City of **HOBART**

APPLICATION UNDER HOBART INTERIM PLANNING SCHEME 2015

Type of Report:	Committee
Council:	28 January 2020
Expiry Date:	31 January 2020
Application No:	PLN-19-856
Address:	THE SPRINGS , MOUNT WELLINGTON
Applicant:	CAROLINE LINDUS 183 MACQUARIE STREET
Proposal:	New Building and Change from Temporary Food Services Use and Development to Permanent Food Services Use and Development
Representations:	Nil
Performance criteria:	Use; Landscape, Visual Quality and Amenity; Car Parking Provisions; and Building Siting

Fig. 3. Proposed site plan.

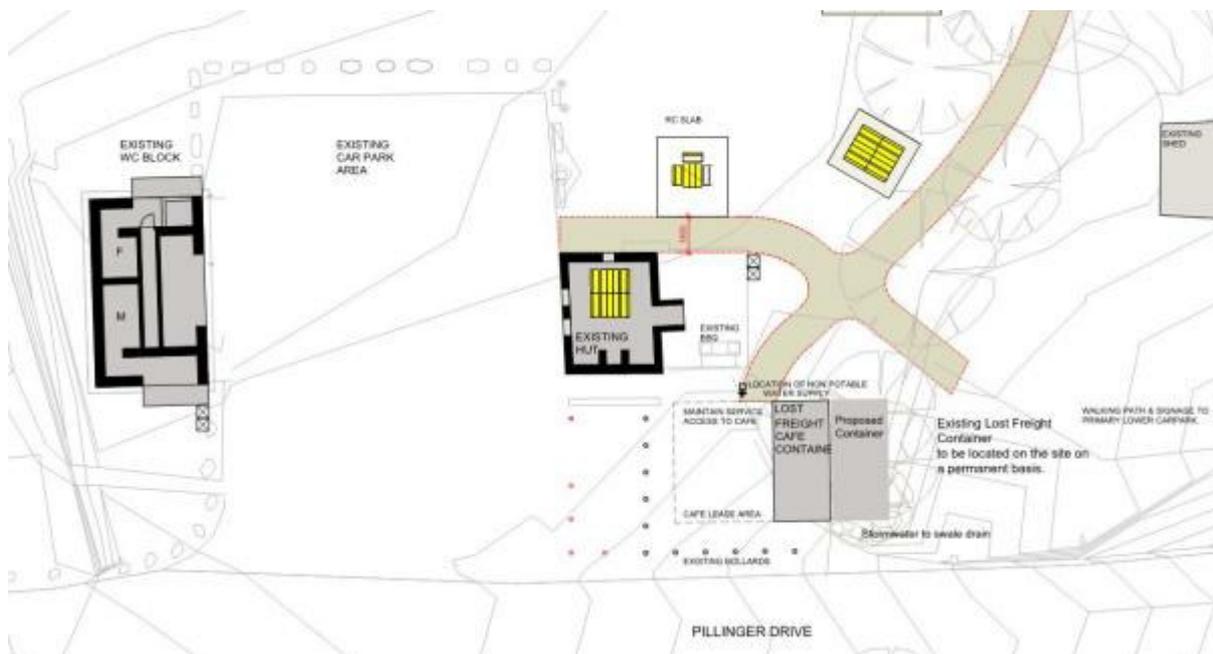
No excavation is to occur beyond the proposed footprint of the new container. Excavation within the footprint of the new container is to be the minimum necessary to level the container. Back-filling with fine crushed rock between the sleepers is required.

Fig. 4. Elevation of the proposed new shipping container.

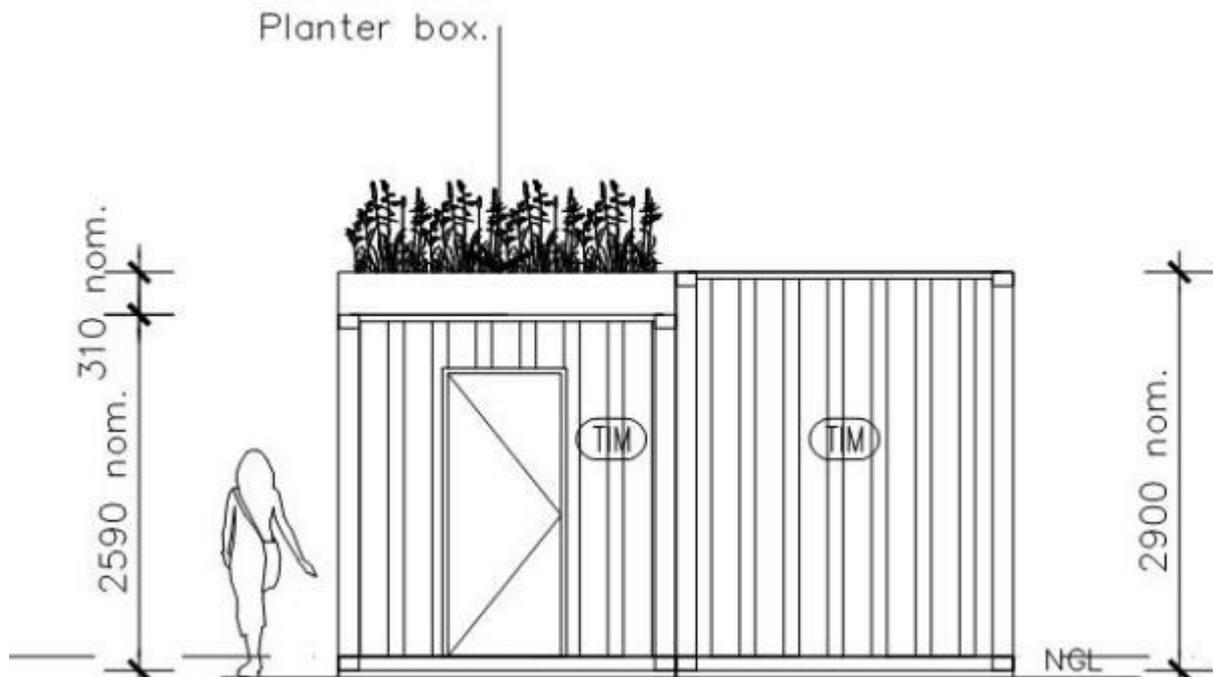
The building is single storey and is 2.9m high. The acceptable solution is met.

The external walls will be non-reflective, clad in timber and painted dark tones of green. No external lighting is proposed. The acceptable solution is met.
